Solicitation Addendum

Addendum No.: 2
Solicitation No.: 23-TA004919DJ
Project No.: 5163680
Solicitation Title: North County Metal Gravity Sewer Pipe Replacements
Addendum Date: October 27, 2023
Procurement Contact: Dave Janney, Procurement Agent III

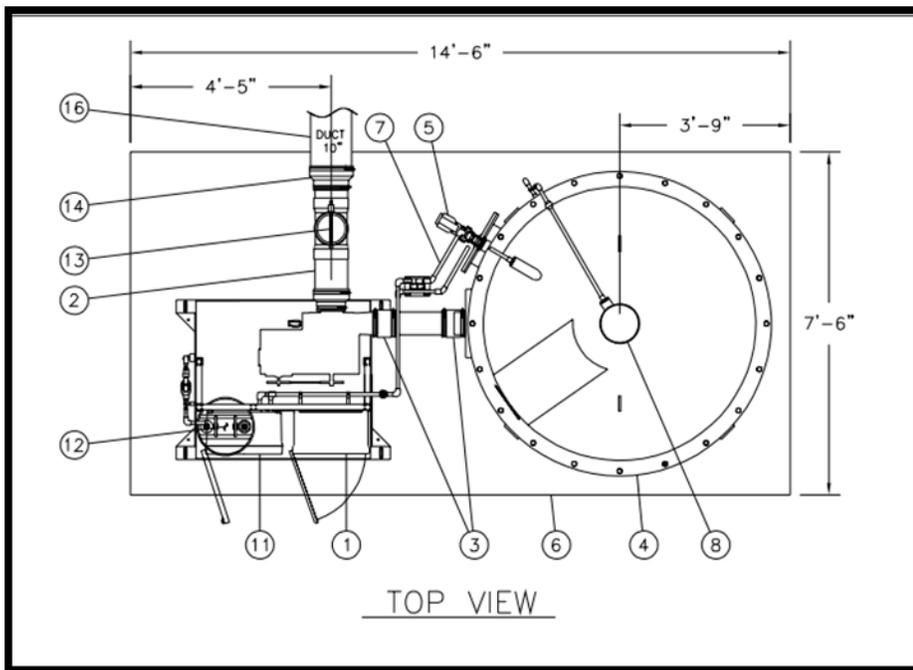
Q7. Sheet C-6 - The temporary and permanent Oder Control Unit is stated to be provided by others. Is there any lead time associated with these two units? Also, it states the contractor is to install them, are their manuals or unit numbers for these units to provide information on how these are to be installed per the manufacturer.

R7. Evoqua will provide the temporary odor control and permanent odor control. Please coordinate the timing with the following:

The temporary skid will be provided by Evoqua and installed by the selected contractor (electrical, water/drain plumbing, air piping) including all connections. The temporary unit skid is shown below.
